Office Action Summary	Application No. 10/743,857	Applicant(s) VON OEPEN ET AL.	
	Examiner Vy Q. Bui	Art Unit 3773

DETAILED ACTION***Election/Restrictions***

Claims 36, 38-39, 41-48, 50, 52-62, 64, 66-74, and 76 are rejected under 35 U.S.C. 102(e) as being anticipated by Trapp-5,861,027.

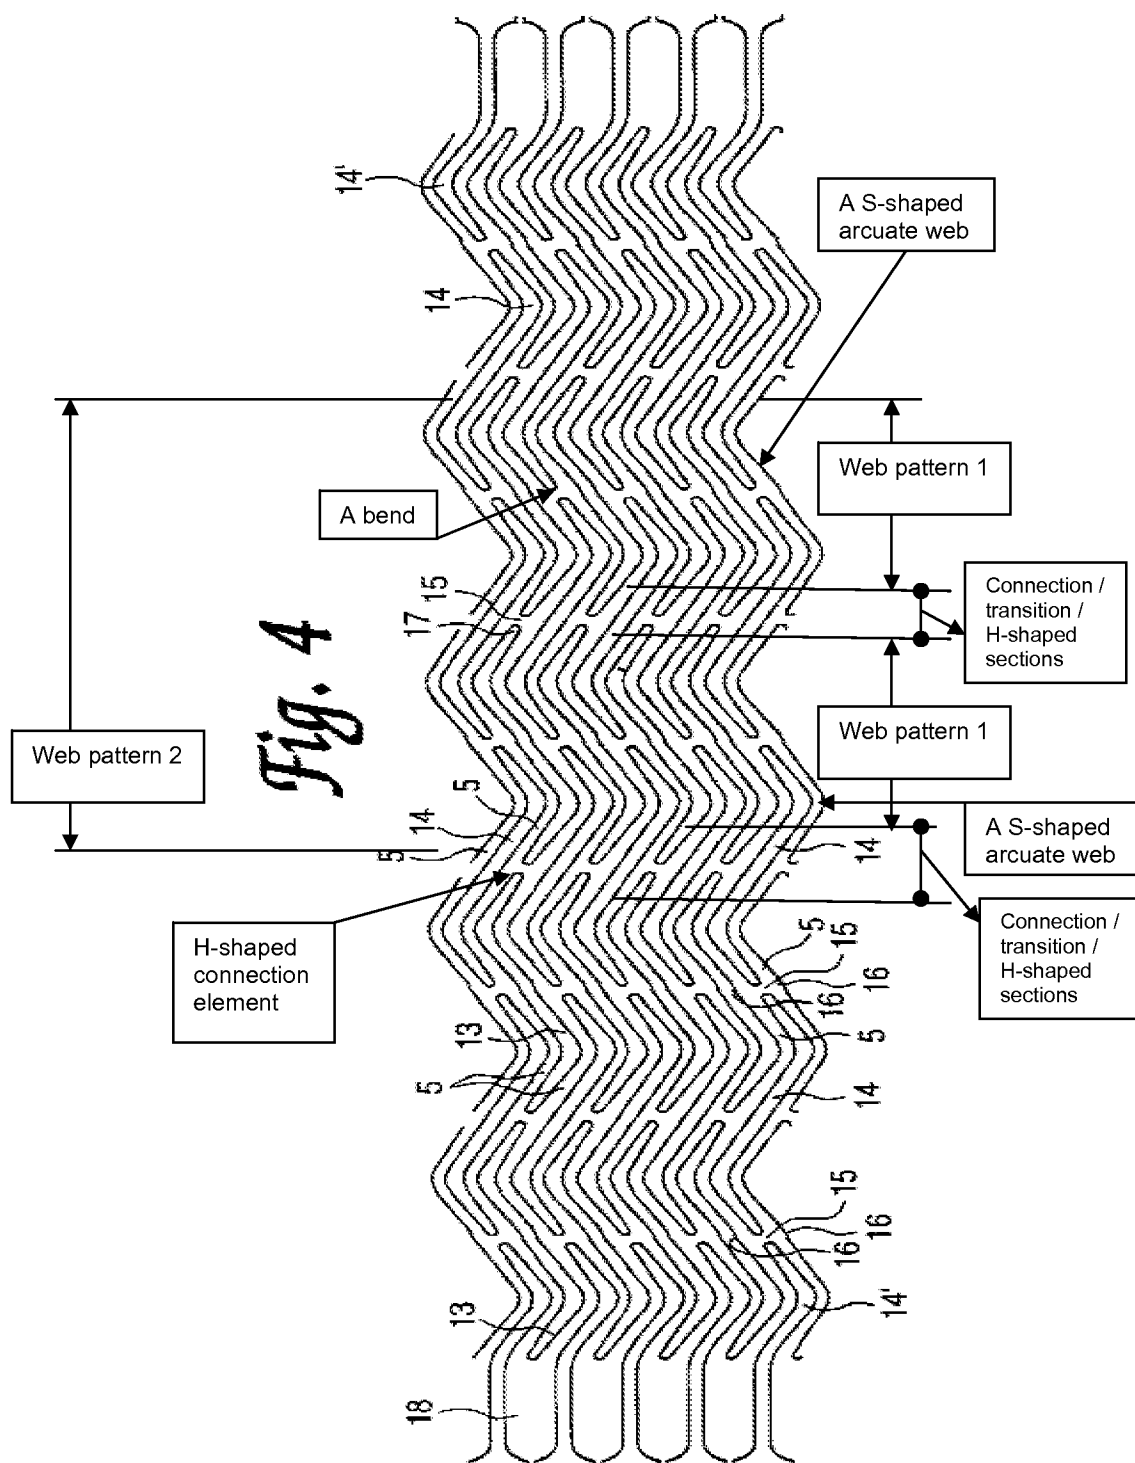
As to 36, 38-39, 41-48, 50, 52-62, 64, 66-74, and 76, Trapp-'027's Fig. 4, for example, discloses self-expanding stents of nitinol and balloon expanding stents of stainless steel or titanium (col. 8, lines 51-56), and a stent structure including arcuate webs defining web patterns, bends interconnecting at the mid-sections of two S-shaped arcuate webs, H-shaped connection elements connecting two web patterns substantially as recited in the claims as indicated on next page. Notice that Trapp-'027 (col. 8, lines 16-21) discloses a coating comprising a nylon, a polyethylene, for example, as a therapeutic agent for a treatment purpose. Alternatively, it is well known in the art to provide a coating of a therapeutic agent, such as a heparin, on a Trapp-'027 stent for treatment a blood vessel.

Independent claims 36, 50, 76 do not require any relative positions of "at least two of the transition sections". Therefore, there are pairs of two selected connection elements that can be selected to meet the requirements (transition sections separated by at least three arcuate webs, or by at least two/four bends, or offset by at least two intervening bends) as recited in the claims (see Trapp-'027's Fig. 4, next page).

As to independent claim 64, S-shaped openings of Trapp-'027's Fig. 4 are considered as intercommunicating because they all are in the same cylindrical surface of the stent.

Further, as to claims 44, 58, 70, Trapp-'027's Fig. 4 shows three arcuate webs define at least an S-shaped structure.

Further more, claim 76, for example, recite the limitation "offset". If two 3-D elements are not fully aligned, they meet the limitation "offset".
